Access Compliance Report

Public Rights-of-Way

(Curb Ramps)

Intersection ID: 14086	Main Street: BALDWIN_AV	Cross Street: E_3RD_ST	Location: W
ADA ID: DF6D58CCA7DA	Ramp Type: Perp	Initial Pass/Fail: Fail	Overall Compliance: No
Severity Score: 18.75			
Codes/Mitigation Info/Possible Solution		Field Measurements/Component Compliance

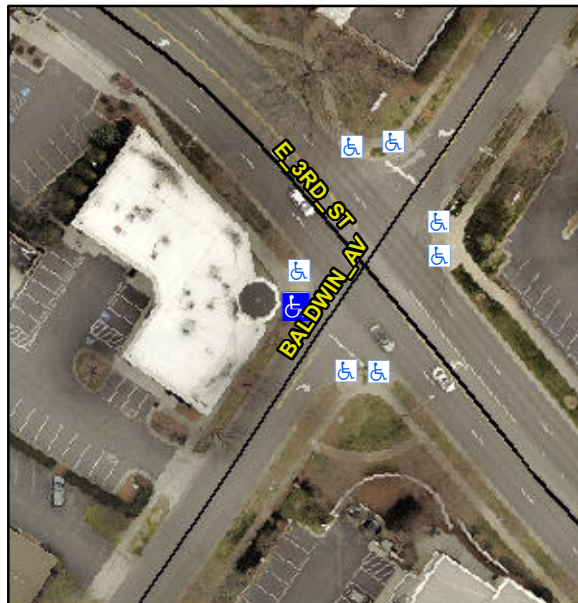
Not Found, R304.5.1, R304.5.3

Compliance	Description	Data	Compliance	Description	Data
N/A	Ramp Length (in)	90.0	Yes	Ramp Slope (%)	5.2
No	Ramp Width (in)	33.0	No	Ramp XSlope (%)	3.0
N/A	Flare Type LT	N/A	N/A	Flare Type RT	N/A
N/A	Flare Slope LT (%)	N/A	N/A	Flare Slope RT (%)	N/A
N/A	Flare Traversable LT?	N/A	N/A	Flare Traversable RT?	N/A
N/A	Landing Length (in)	N/A	N/A	DWS Provided?	N/A
N/A	Landing Width (in)	N/A	N/A	DWS Contrast?	N/A
N/A	Landing Slope (%)	N/A	N/A	DWS Length (in)	N/A
N/A	Landing X Slope (%)	N/A	N/A	DWS Full Width?	N/A
N/A	Landing Curb? (Y/N)	N/A	N/A	DWS Offset (in)	N/A
N/A	Shared Landing?	N/A			
N/A	Gutter Ponding?	N/A	N/A	Gutter Slope (%)	N/A
N/A	Gutter Lip Ht (in)	N/A	N/A	Gutter X Slope (%)	N/A
N/A	Painted X Walk1?	No	N/A	Painted X Walk2?	N/A
	X Walk 1 Direction	To SE		X Walk 2 Direction	N/A
N/A	X Walk 1 Width (in)	N/A	N/A	X Walk 2 Width (in)	N/A
	X Walk 1 Slope (%)	0.7		X Walk 2 Slope (%)	N/A
	X Walk 1 X Slope (%)	0.5		X Walk 2 X Slope (%)	N/A

Remove & Replace Entire Ramp.
